ORIGINATION FORM

Proposed Revisions to a Standard Plans Index
(Please provide all information — Incomplete forms will be returned)

Index Number: 520-005
Sheet Number (s): All
Index Title: Concrete Shoulder Gutter Spillway

DETAIL OF CONCRETE SPILLWAY AT END OF SHOULDER GUTTER
~~(TO BE USED WHERE INLETS, PIPES & ENDWALLS ARE IMPRACTICAL)~~

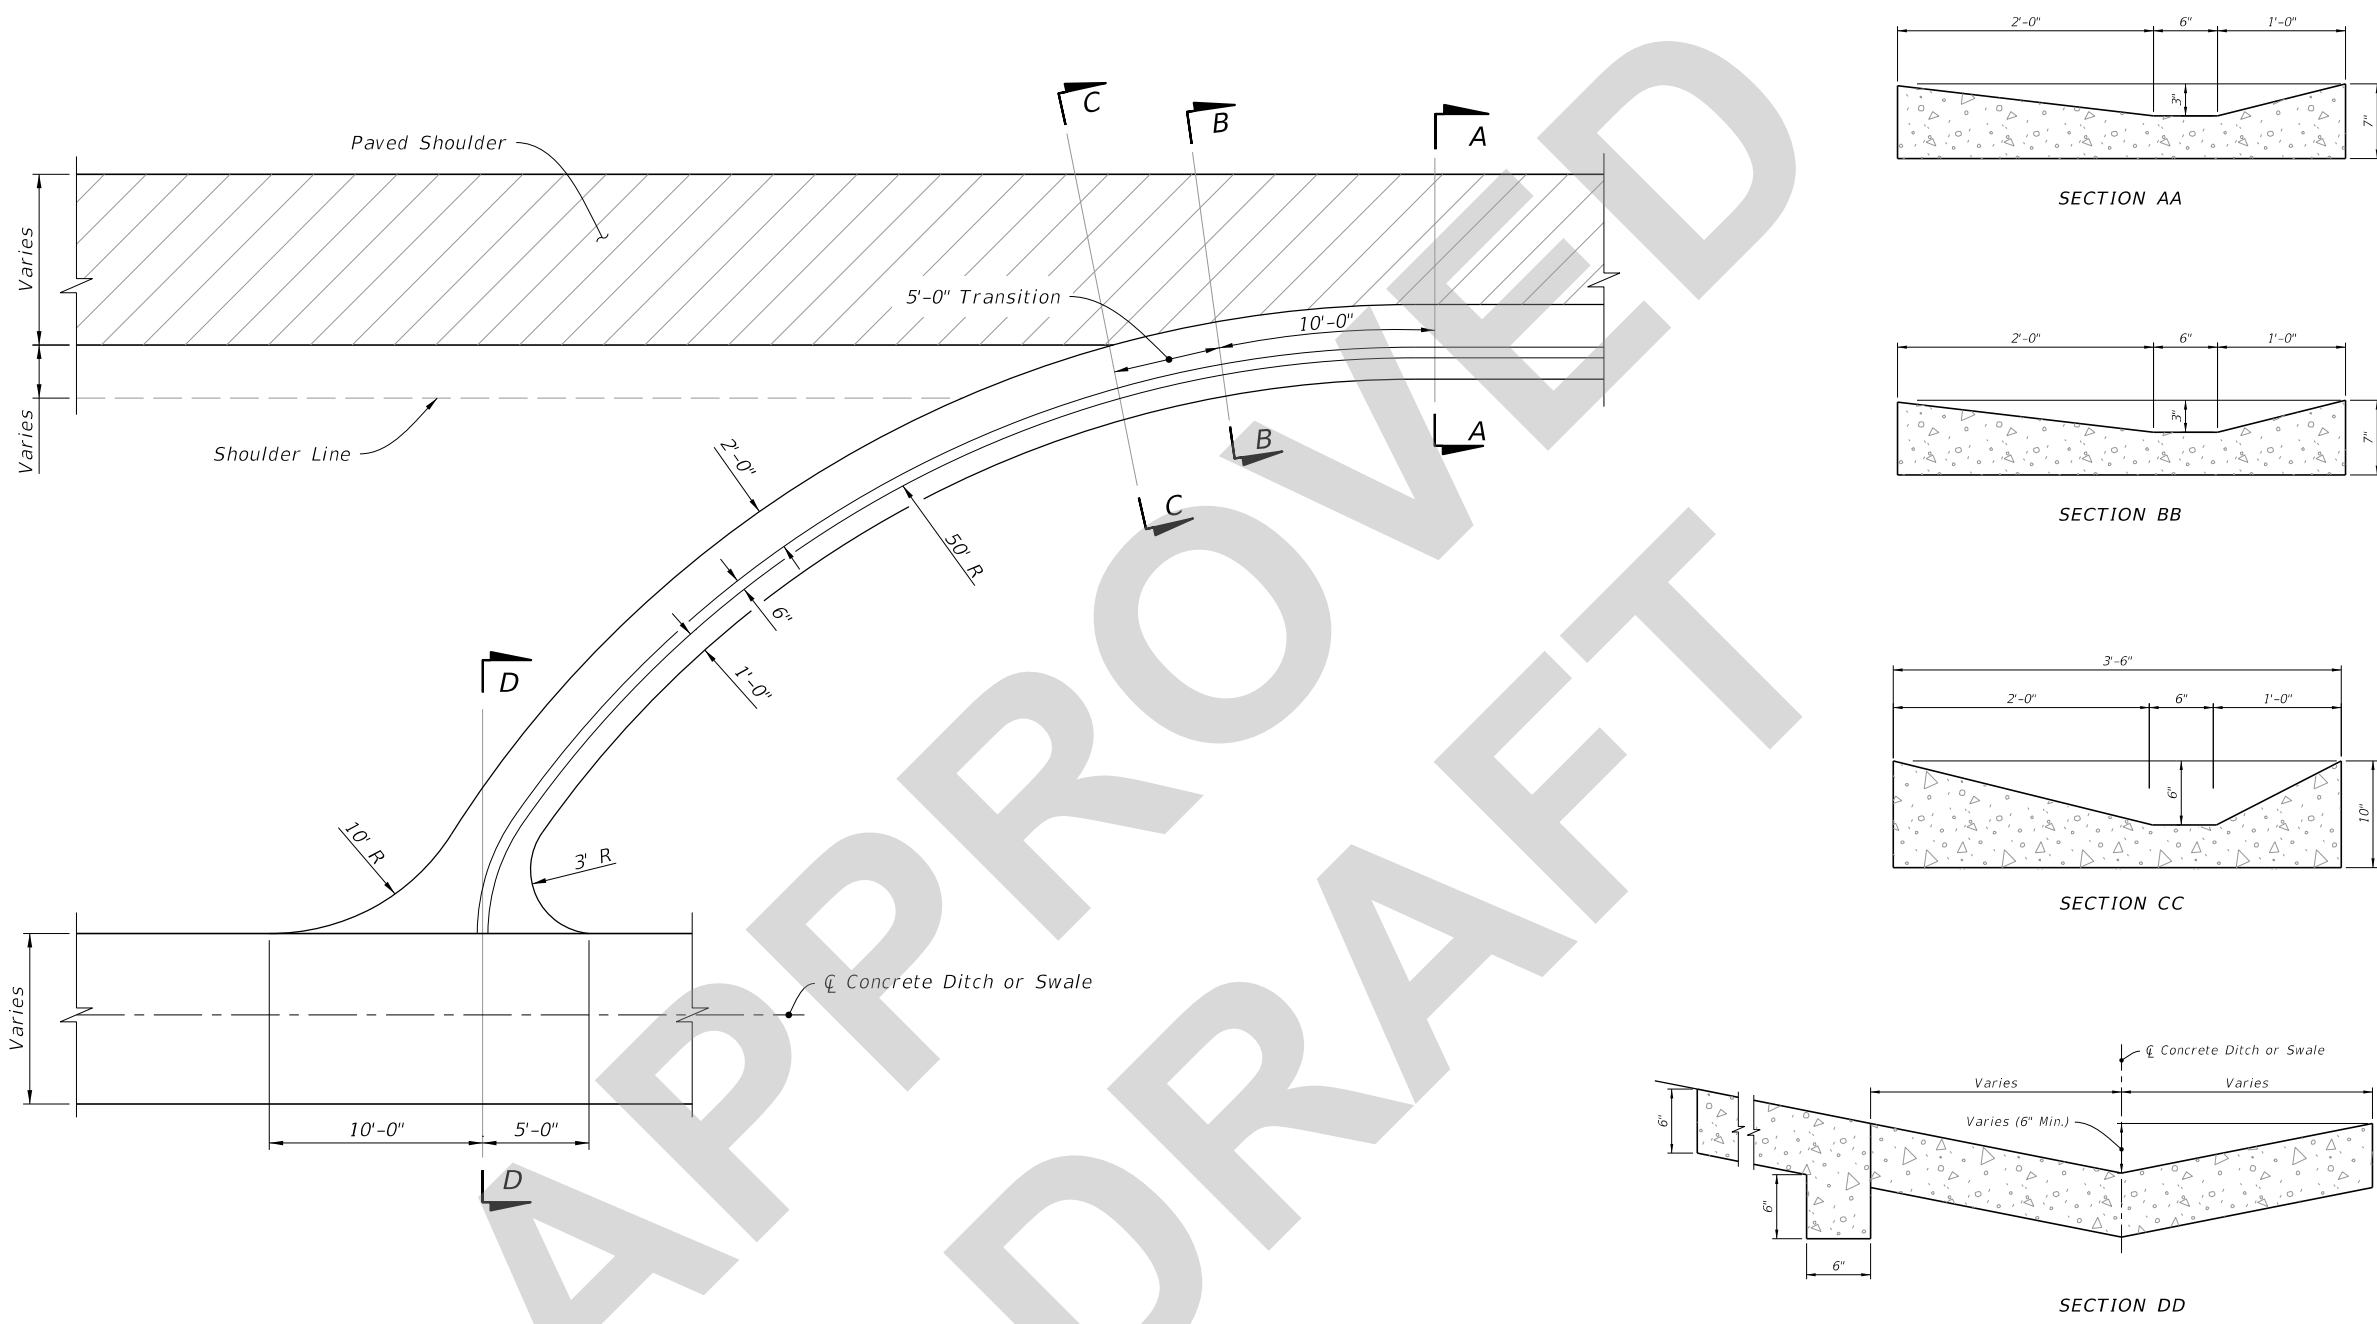
Deleted notes; redrew details.

REDEVELOPED INDEX

- ~~1. Spillway to be paid for as Shoulder Gutter, L.F.~~
- ~~2. If spillway empties into an unpaved ditch, the detail should be modified as necessary.~~
